Product Change Notification

110099 - 00

Change Notification #: 110099 - 00
Change Title: DG41TX, PCN 110099-00, Product Design, BIOS update and adding alternate component to improve manufacturability
Date of Publication: June 10, 2010

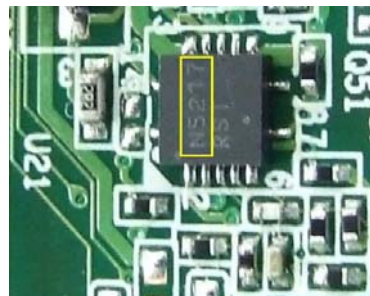
1. BIOS update to TXG4110H.86A.0043. To access release notes or a copy of the BIOS for evaluation, go to <http://downloadcenter.intel.com>
2. Added a second source vendor for the component at location U21 to ensure adequate supply. Body markings of both components are shown below:

Component marking: **TI** xxx

Component marking: **N**xxxxx
